5415 Mohican Road, Bethesda
HPC Case # 35/29-11B
Master Plan Site # 35/29
Baltimore Castle

MEMORANDUM

SUBJECT: Historic Area Work Permit #584817, construction of addition and garage and other alterations

MONTGOMERY COUNTY HISTORIC PRESERVATION COMMISSION
STAFF REPORT

1 MICHIGAN ROAD ELEVATION
Scale: 1/4" = 1'-0"

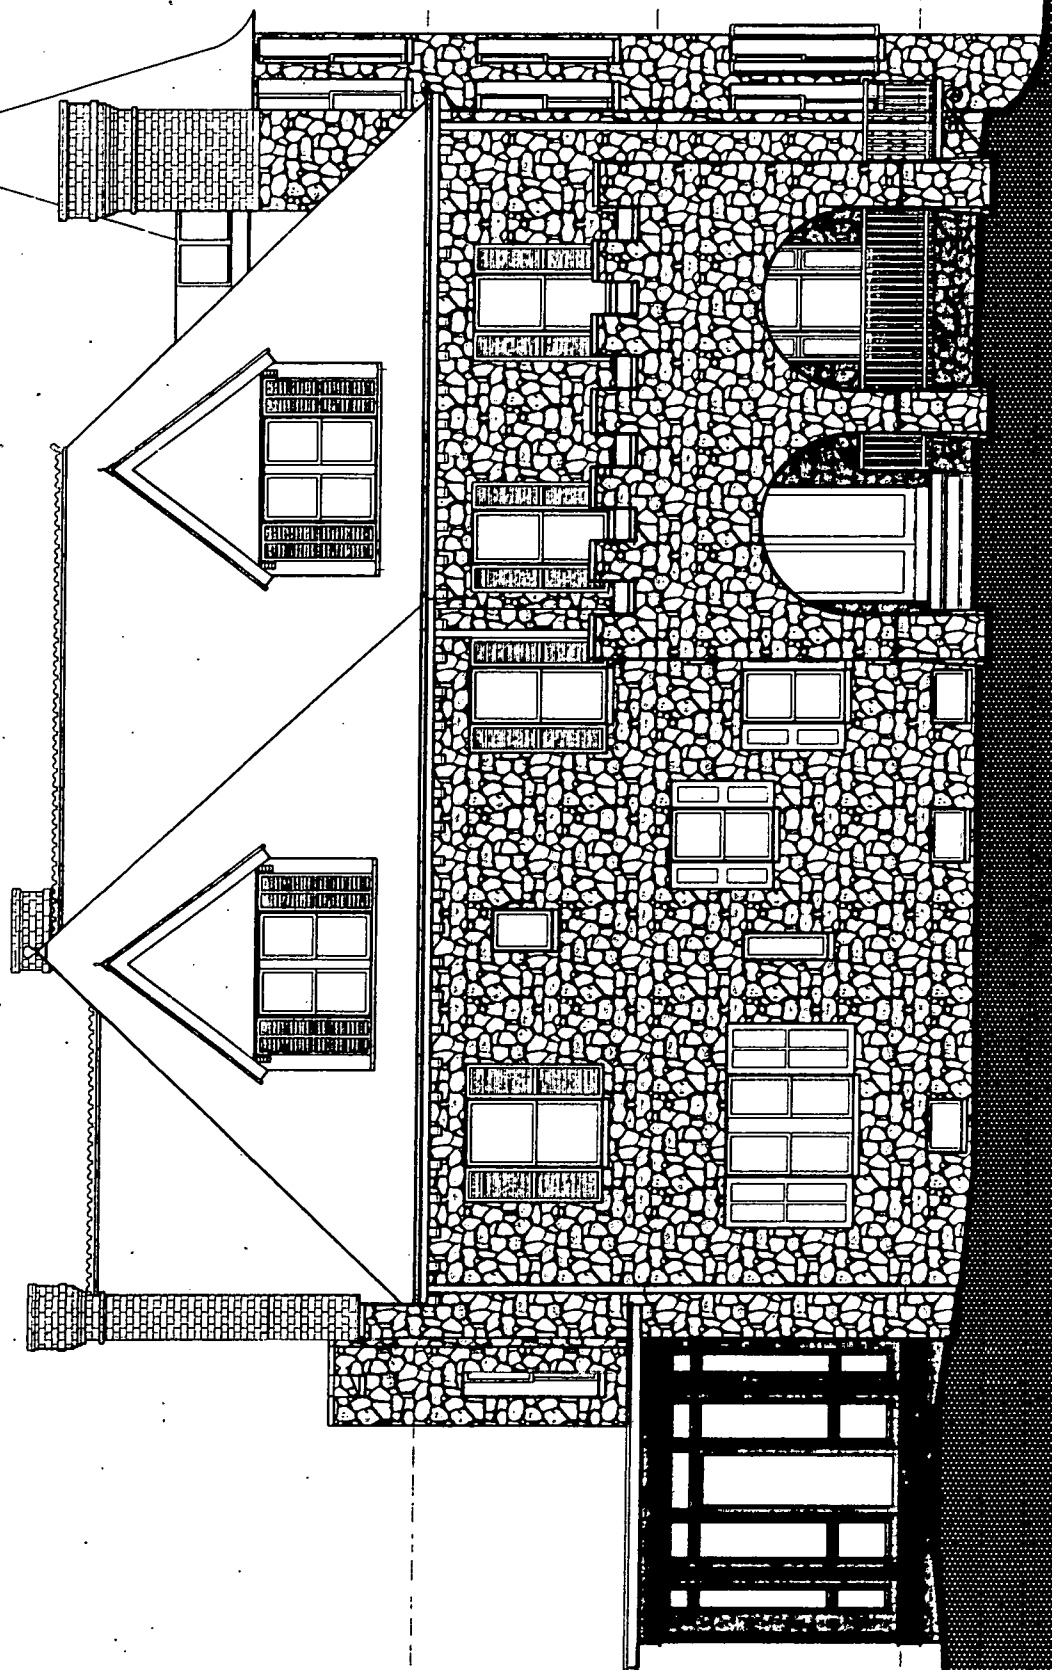
- 1. The right side fascia board of the roof on the 2 story side addition cannot extend beyond the rear wall plane of the historic massing.*

GARAGE PLANS

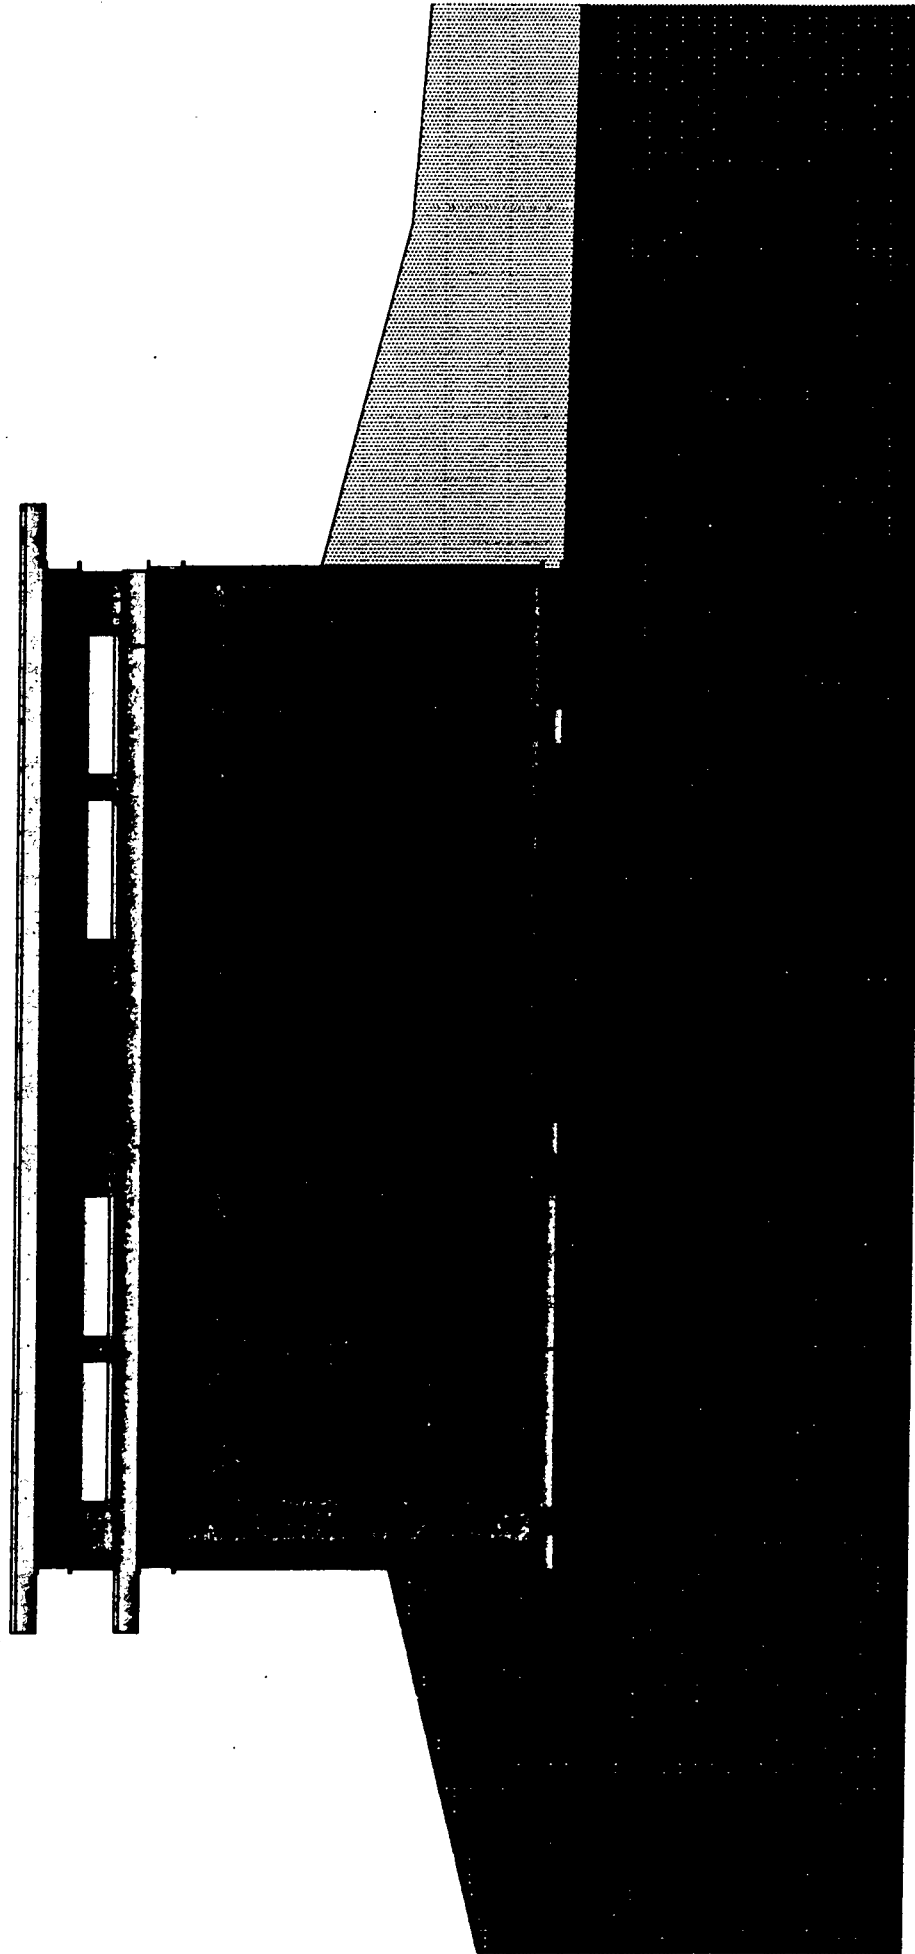
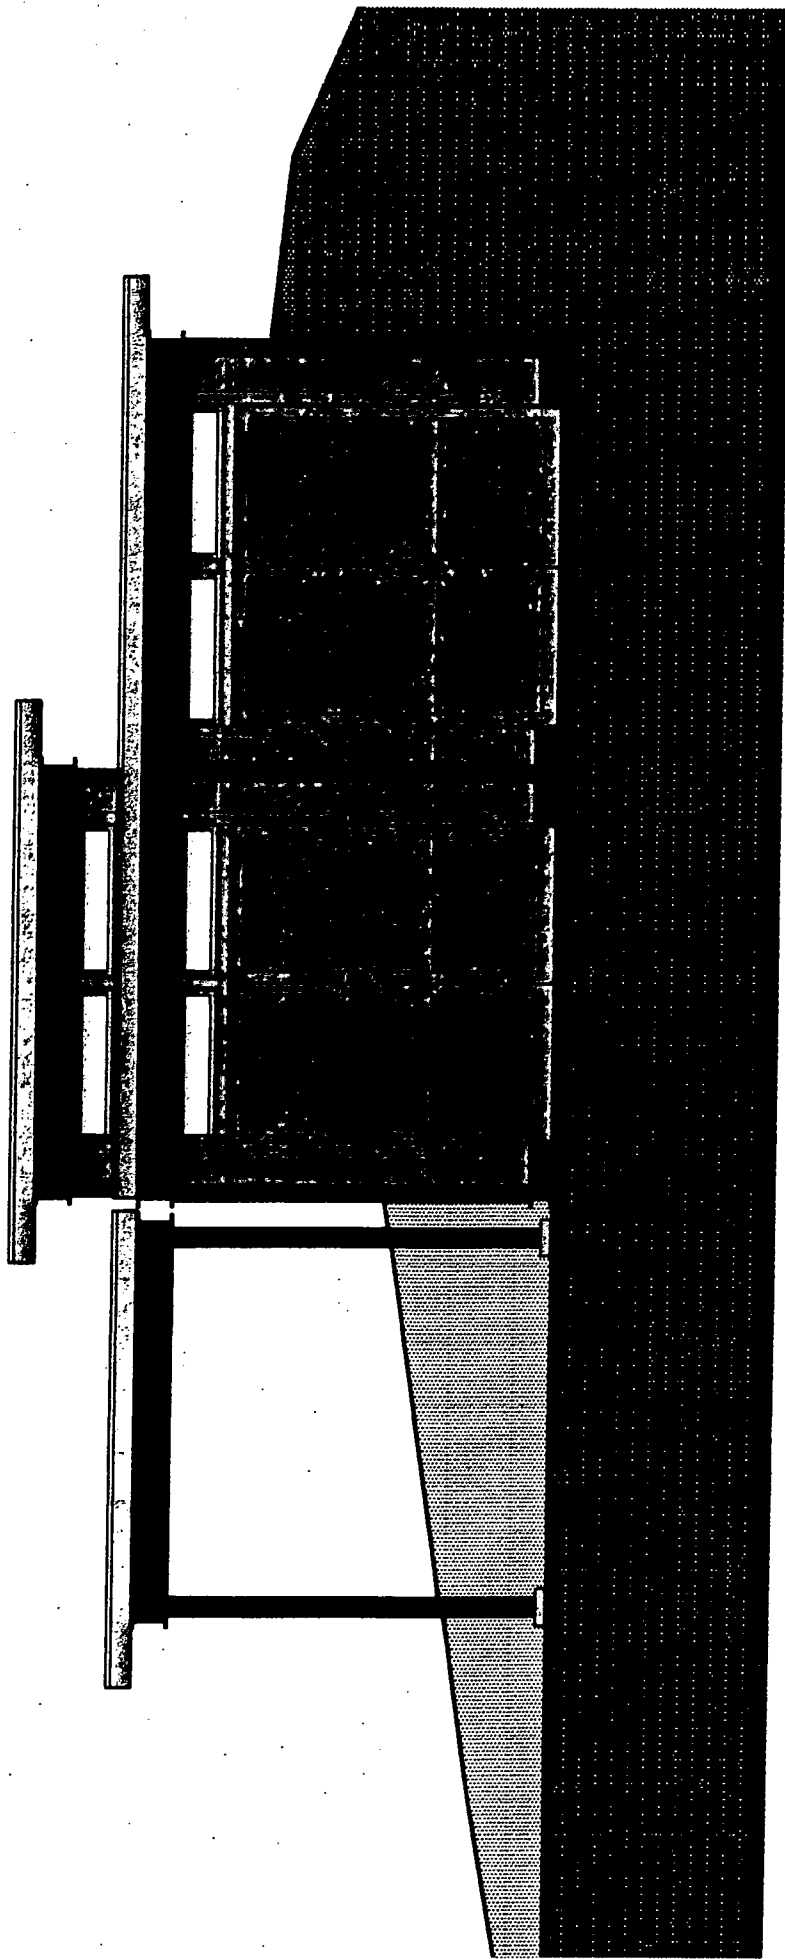
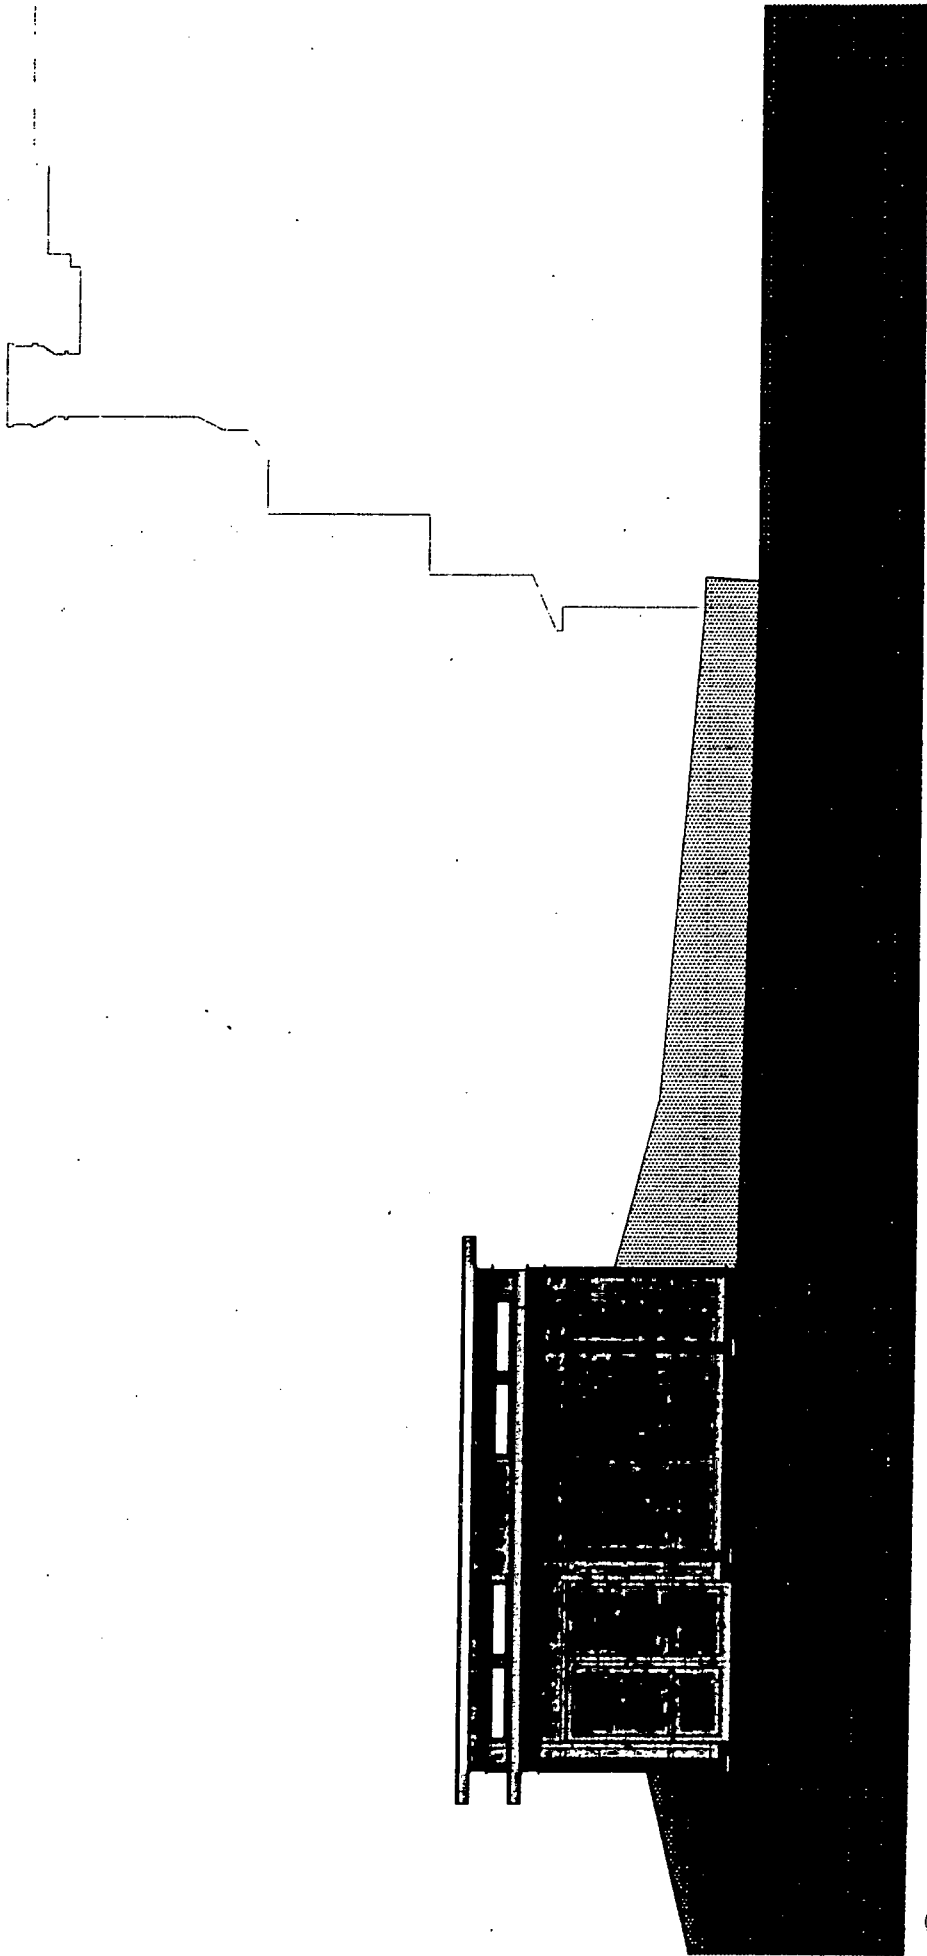
Staff supports the proposed construction of a two car garage with a single detached car port. The redesign responds to the HPC's feedback by including similar and matching materials treatments and design details as the proposed side addition. The applicants have confirmed the redesign complies with the properties established setbacks.

5415 MOHICAN ROAD
FRONT PORCH DETAIL - PARTIAL L SIDE
ELEVATION, PLAN & GLAZING DETAILS

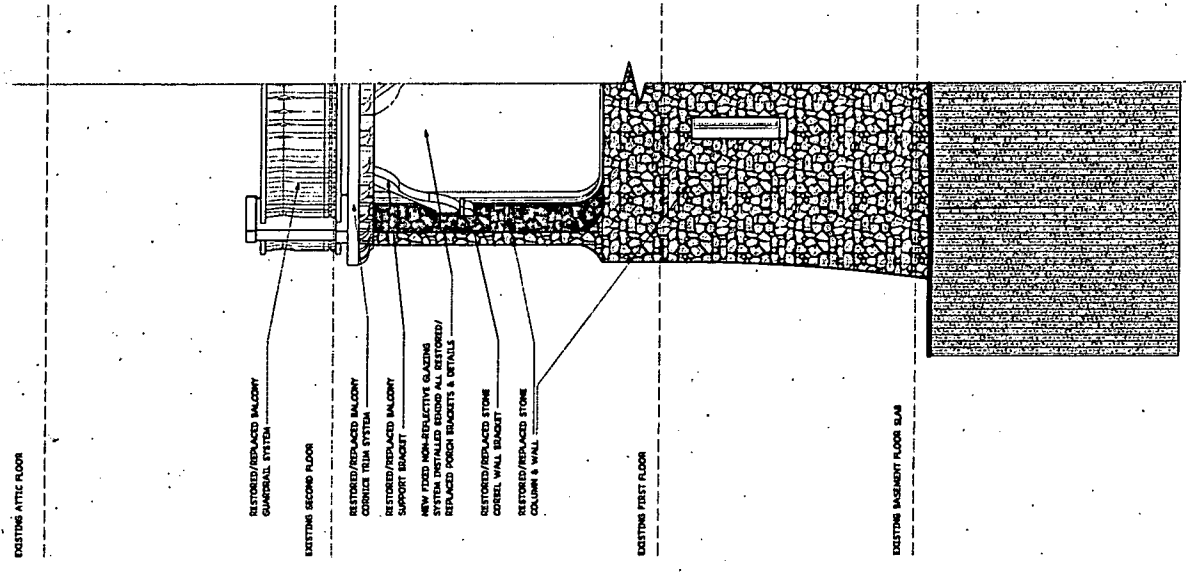
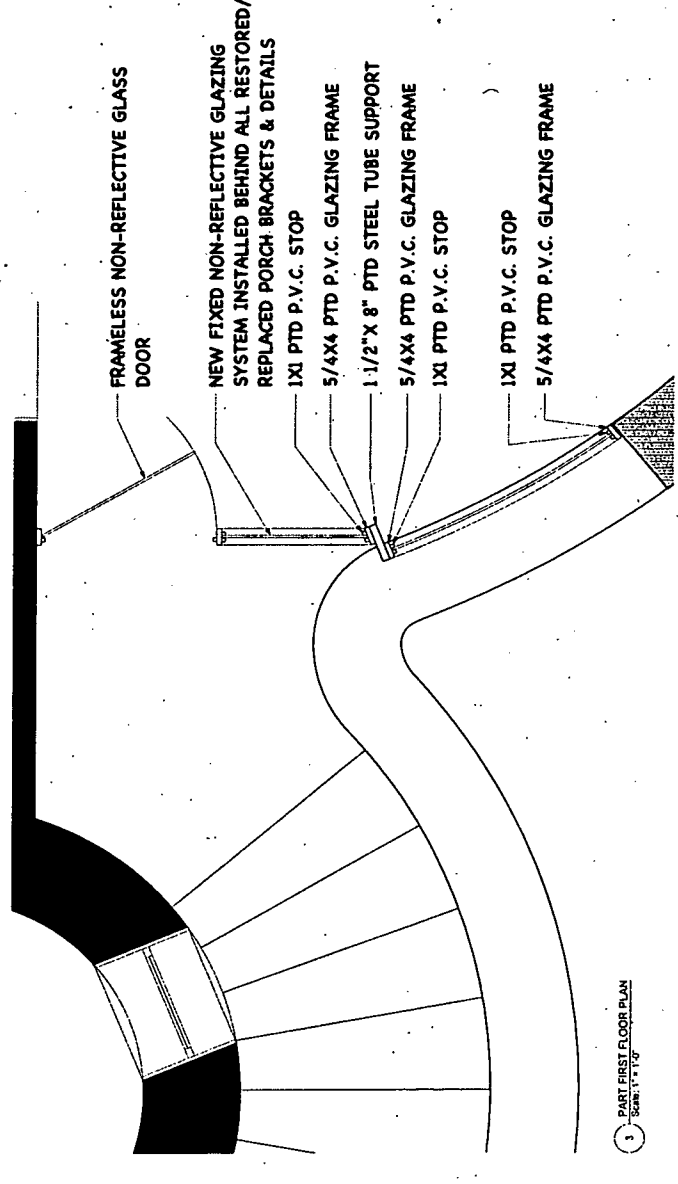
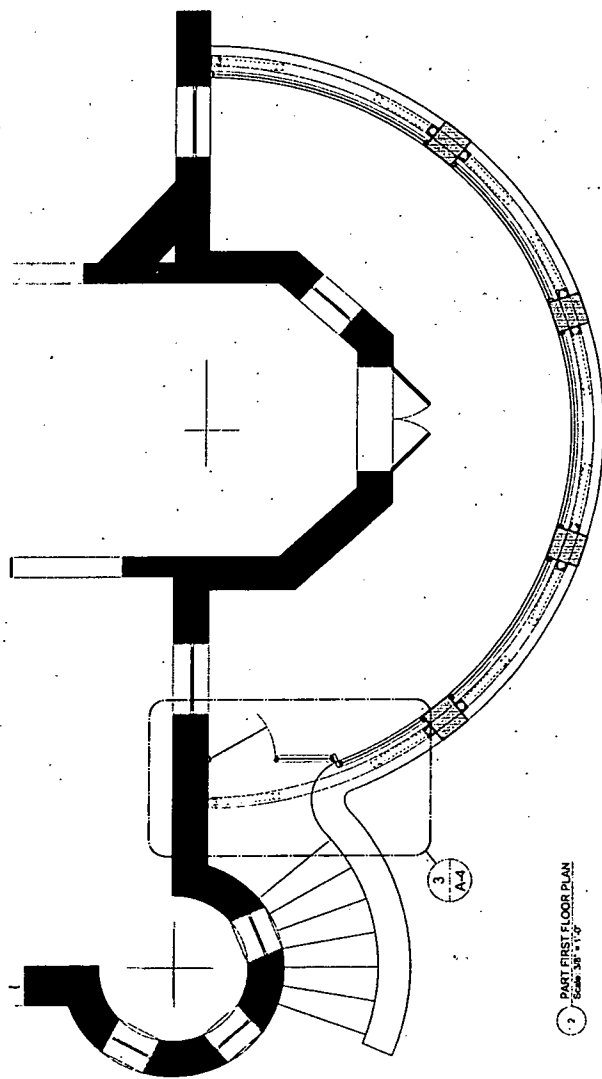
Staff supports the proposed installation of non-reflective glass in the openings of the front porch. The proposed installation of full view, fixed, non-operable glass sections behind the decorative wood brackets will have negligible impact on the structure and is consistent with Secretary of the Interior Standard's for Rehabilitation #1, 9 & 10. The applicant has provided additional details about the porch glass and door attachments and included a structural analysis of the front porch pilasters and glass panel installation method to assist the HPC in their review of this project. (See circles 35-36).

10 MR. RODRIGUEZ: I understand but the glass is
11 supported by the masonry and the pressure that the wind
12 serves over the glass is going to be transferred to the
13 masonry and what my recommend is you have to consult and be
14 sure that that detail is done properly. Otherwise, all the
15 reconstruction of the porch that you're going to do is going
16 to be cracked over time once all this pressure goes back to
17 the masonry because those pilasters weren't designed to have
18 all these loads that you are adding now. I'm no
19 construction engineer but one of our Commissioners is an
20 engineer and he probably can explain a little better than
21 I'm doing at this moment; but I think it's an issue that I
22 will definitely recommend you consider carefully because
23 it's a detail that can in the long term effect the stability
24 of the structure.

10 And I'll address a bit the anchorage of the glass
11 curtain wall to the masonry. I don't think on a global
12 basis you'd have a problem determining that the stone piers
13 could support some additional wind load from the glass. I
14 do think, again, it's a detail issue of making that
15 connection where you're very close to the corner of the pier
16 and, you know, one thing we want to make sure is that this
17 is a reversible addition, there's no permanent damage. Part
18 of that I think your anchors are probably going to be in
19 irregular spacing and target the mortar joints so that you
20 avoid cracking a stone with cracks that would propagate out.
